City of Somerville

URBAN DESIGN COMMISSION

DESIGN REVIEW RECOMMENDATION

50 Webster Ave

Façade Evolution

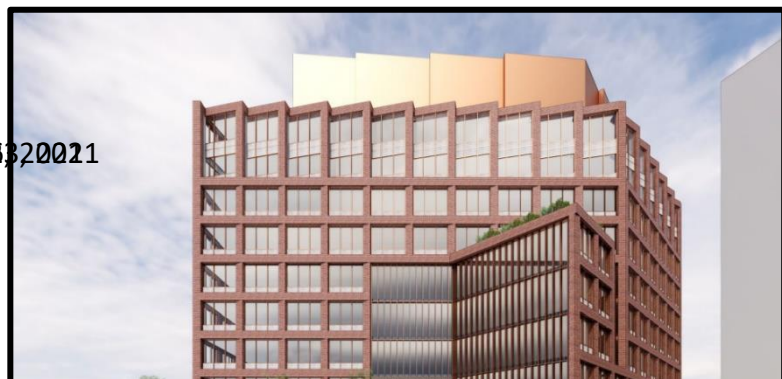
- Penthouse should not be as prominent. Revise penthouse design to be a secondary component of the building and overall have a less imposing effect. Examine using a finer grade for the serrated edges at the top of the penthouse, changing the materiality. Building design included larger penthouse setback along west side of the building, this should be maintained. Penthouse should be set back to minimize visibility from adjacent proposed civic space and sidewalk along the east side of Prospect St and Webster Ave.

- Building materiality needs to be examined further, pursue the use of red brick consistent with what the project team presented at their first UDC design review. Concerns expressed about switching from stone to concrete at the ground floor and tactile quality of textured concrete where people will touch it.
- Proposed cut glass column needs to be developed further. Needs to engage more with the rest of the building and proposed civic space in front.
- Look for opportunities to add additional variation to the long, repetitious north building elevation. Also explore adding screening such as a green wall all or art at the lower level concrete face facing the GLX station.
